App Note 3479: DS2154 – Migrating from Revision A2 to D1

This application note describes the procedures for replacing the A2 revision of the DS2154 with the D1 revision of the DS2154. The D1 revision of the DS2154 is a drop-in replacement for the A2 revision of the DS2154. However, it is possible that the user may experience a timing-related issue while replacing the parts. This application note will describe what to do to correct this problem.

Figure 4. Transmit-Side Timing Between TSYNC and TCLK Taken from an Oscilloscope

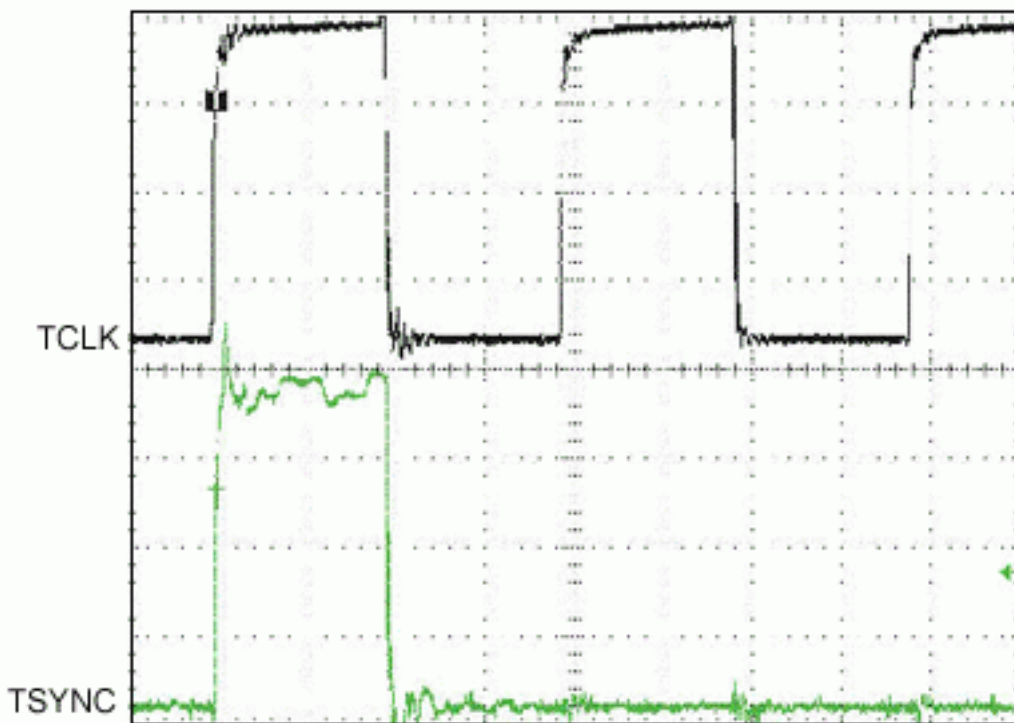
In the DS2154 D1 revision, when TSYNC is configured as an input by setting $TCR1.0 = 0$ ($TSIO = 0$), the E1 SYNC signal sometimes does not synchronize correctly with the MSB of time slot 0 (TS0). **Figure 4** is the scope image of a possible valid timing diagram between TSYNC and TCLK for the DS2154 A2 revision. However, this is not valid for the DS2154 D1 revision.

Figure 4 shows the falling edge of TCLK and TSYNC as being nearly simultaneous. In the D1 revision, the incoming TSYNC is sampled at the falling edge of TCLK. In order to get the correct sampling, the user needs to add 25ns or more delay onto TSYNC. The user can also make the clock pulse of TSYNC wider. This way, the user can solve the sampling problem. The A2 revision of the DS2154 has a rising edge detector to aid in aligning TSYNC with TS0. The D1 revision of the DS2154 simply samples TSYNC with the falling edge of TCLK. **Figure 5** shows the timing diagram between TCLK and TSYNC after making the TSYNC pulse wider.

When replacing the A2 revision of the DS2154 with the D1 revision, most applications will never experience this timing issue. However, if the application experiences this problem, it is recommended to increase the TSYNC delay by 25ns or to widen the TSYNC pulse. For further questions about the operation of the DS2154, please contact the Dallas Semiconductor Telecommunications Applications support team through email: telecom.support@dalsemi.com, or phone: 972-371-6555.
